## Measurement of the sound emitted by stationary vehicles

(Proposal for draft amendments to Annex 3 to Regulation No. 51)

Figure 1: Reference point

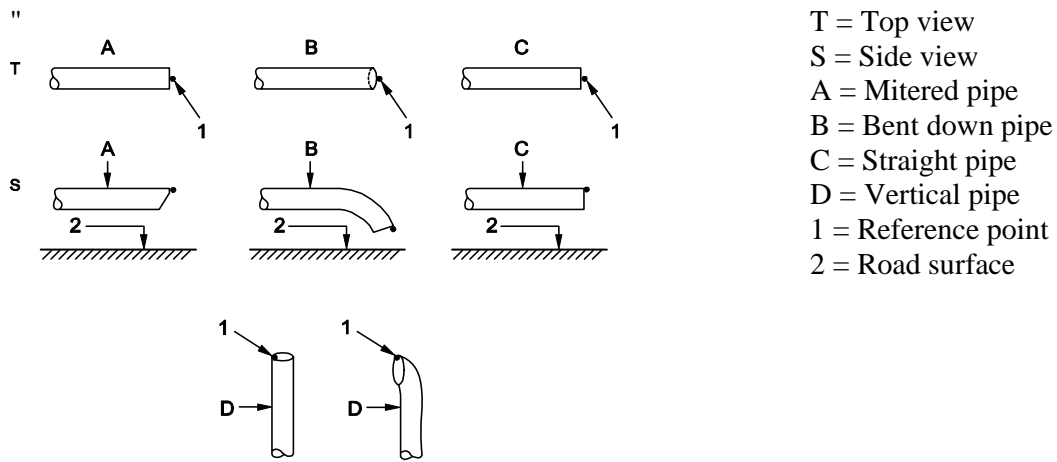
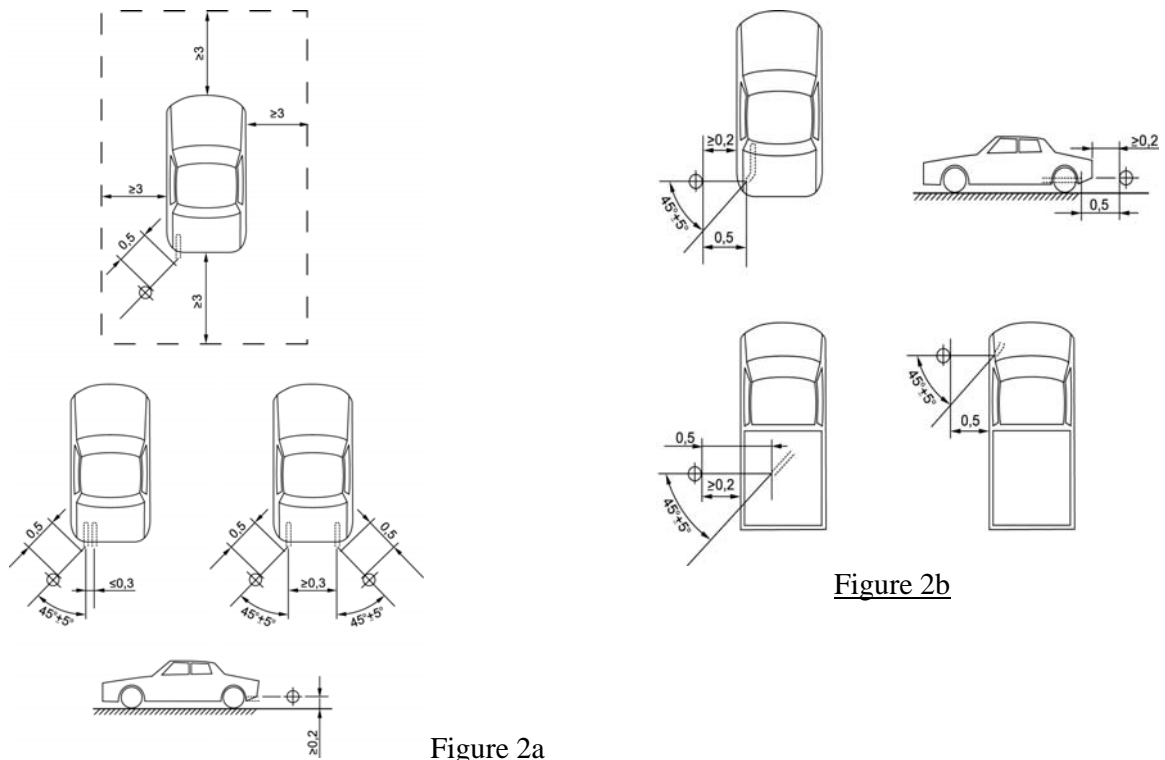
The local conditions for determination of the reference point are indicated in the figures of Annex 3, and as shown below, ISO proposes to introduce new figures 1, 2a, 2b, 2c and 2d.

Figure 2c

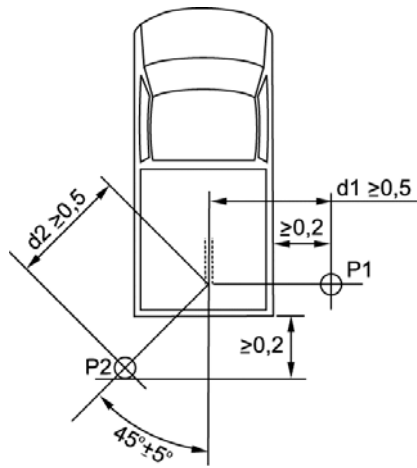
"3.2.5.3.1.6. For vehicles, **where the reference point of the exhaust pipe is not accessible, or located under the vehicle body, as shown in figure 2b and 2c, because of the presence of obstacles which form part of the vehicle (e. g. spare wheel, fuel tank, battery compartment), the microphone shall be located at least 0.2 m from the nearest obstacle, including the vehicle body, and its axis of maximum sensitivity must face the exhaust outlet from the position least concealed by the above mentioned obstacles.**

**When several positions are possible, as shown in figure 2c, the microphone position giving the lowest value of d1 or d2 shall be used.**

Figure 2d

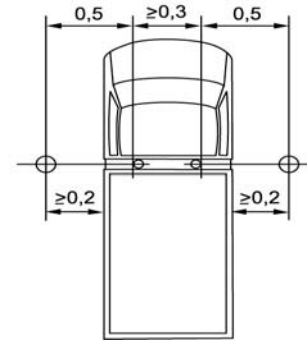
Figures from 2a to 2d show examples of the position of the microphone, depending on the location of the exhaust pipe."
